**Lila Canyon Project**  
**P. O. Box 910**  
**East Carbon, Utah 84520**  
**Phone: (435) 888-4000**  
**(435) 650-3157**  
**Fax: (435) 888-4002**

Re: Lila Canyon Mine  
L16-003 Drainage Revisions Task ID# 5056

| Title of Proposal: L16-003 Drainage Deficiencies Task# 5056 |                                     |                                  |                                   |                                      |                                       | Mine: Lila Canyon                    |

LILLA CANYON MINE  
 PROPOSED SEDIMENT POND #1  
 DATE: APRIL 2008  
 SCALE: AS SHOWN  
 SHEET: 7-6a

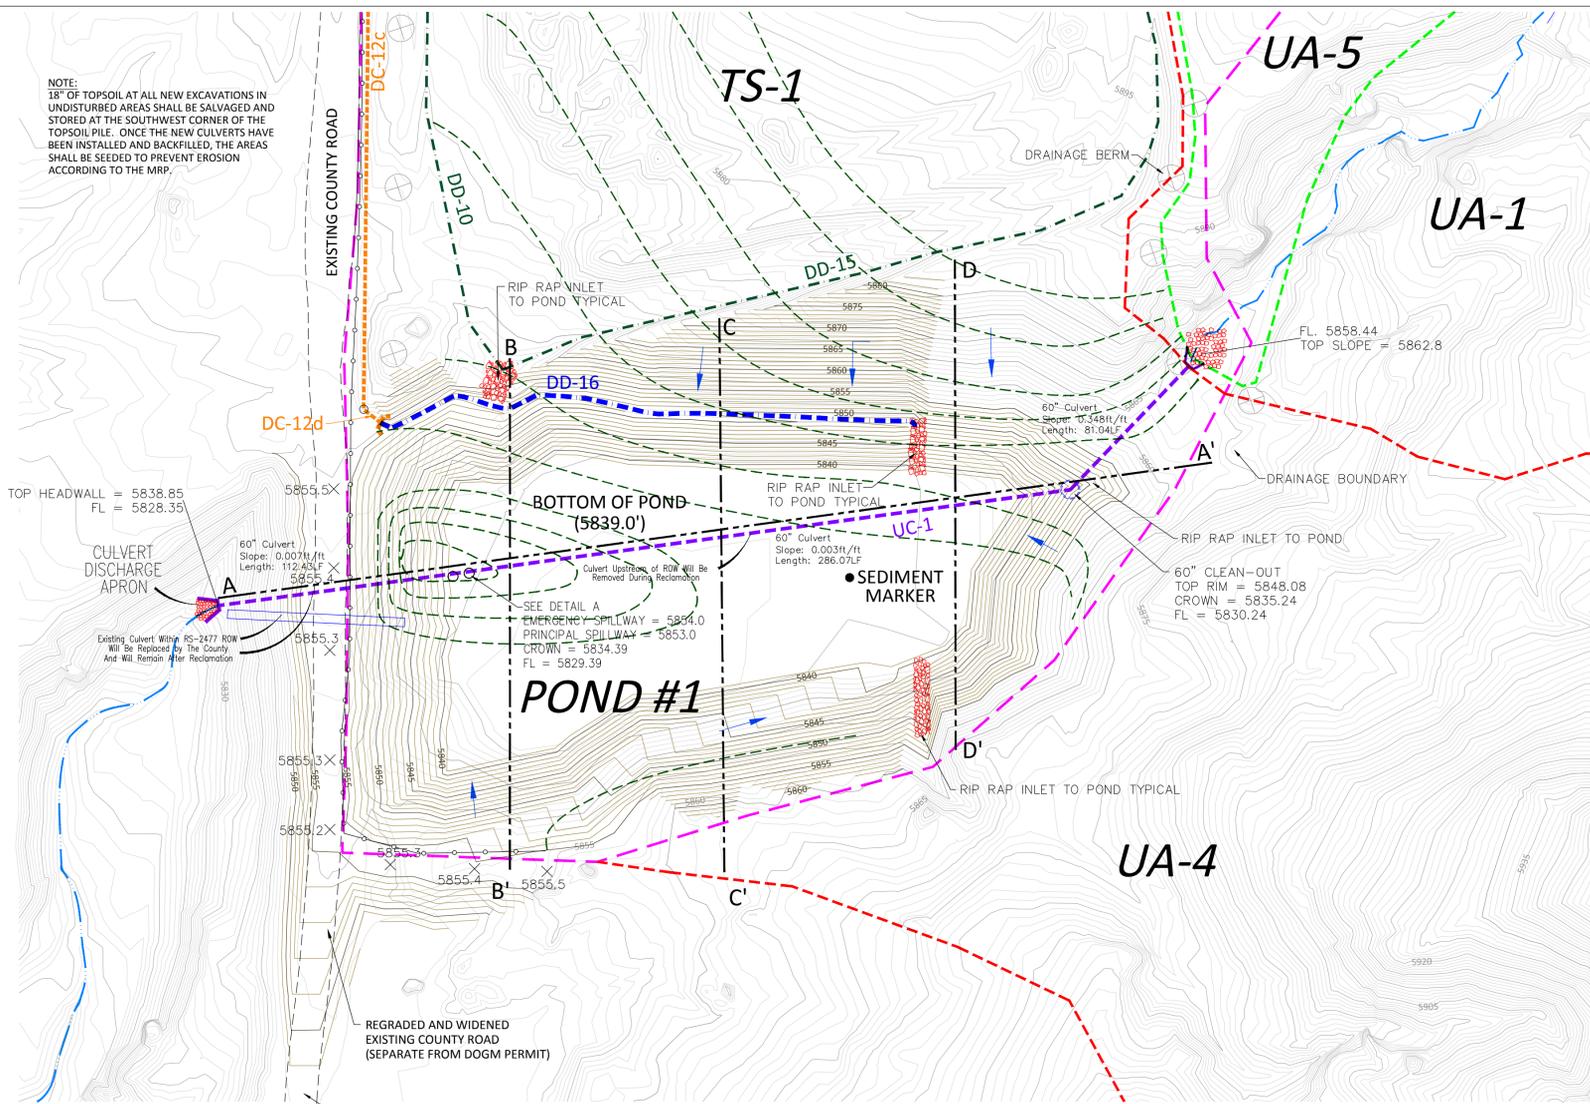
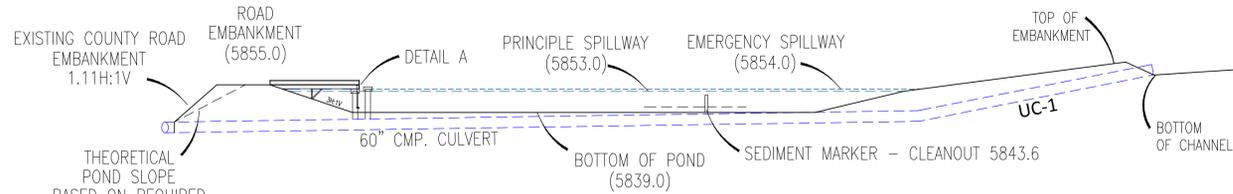
R645-301-542.800, R645-301-830.140: The Permittee must provide detailed grading volumes for the new reclamation requirements for all ditches and pond 1 shown on Plate 7-5.

K:\14\161616\_14-001 Design and Detail\14-001\14-001.dwg, Title: 14-001.dwg, Date: 2/1/2008, Author: David W. Hibbs, License: 6449661, State: CA, Project: Lila Canyon Mine, Sheet: 7-6b

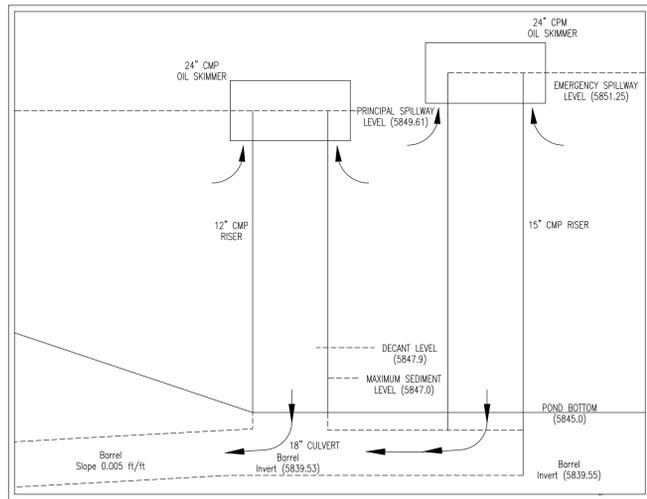
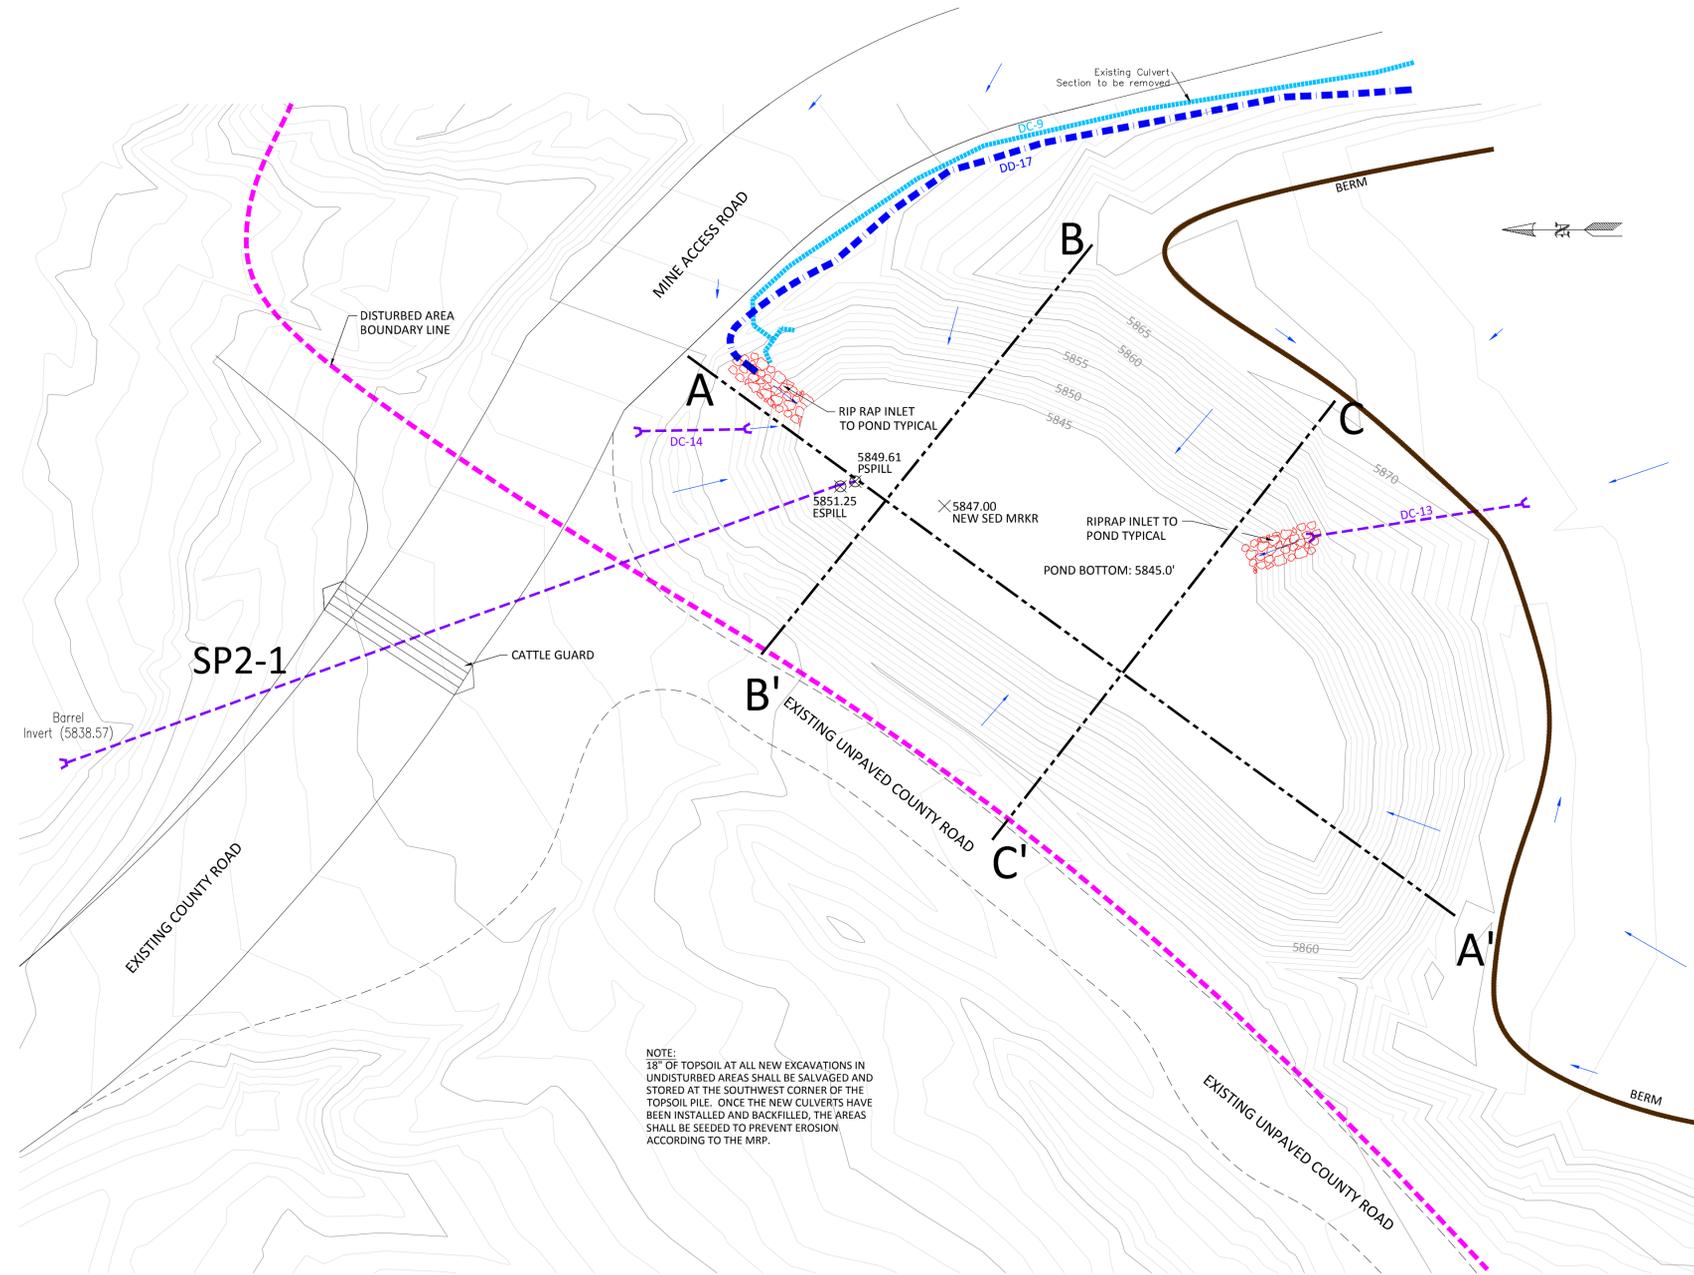
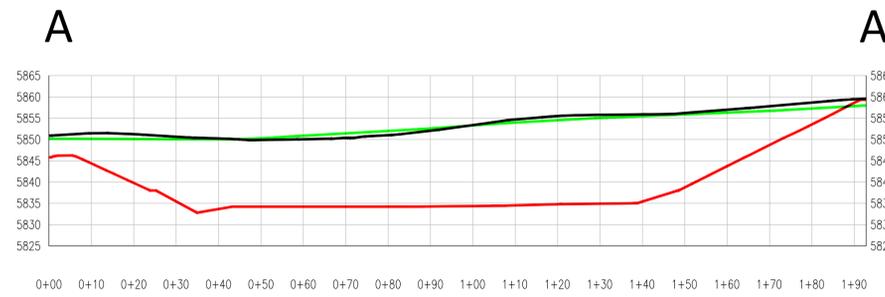
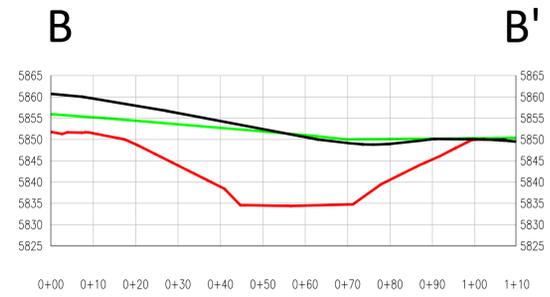
R645-301-121.200, (1) Plate 7-5b should show the locations of flow entering the pond either by culvert or ditch. (2) If topsoil remains in the path of culverts to be installed, the application must call out to soil salvage, storage and protection.

Plate 7-5b has been revised to show the locations of flow entering Pond #2. Topsoil salvage and storage is noted for all new excavations in undisturbed areas on Plates 7-2, 7-5, 7-6a and 7-6b.
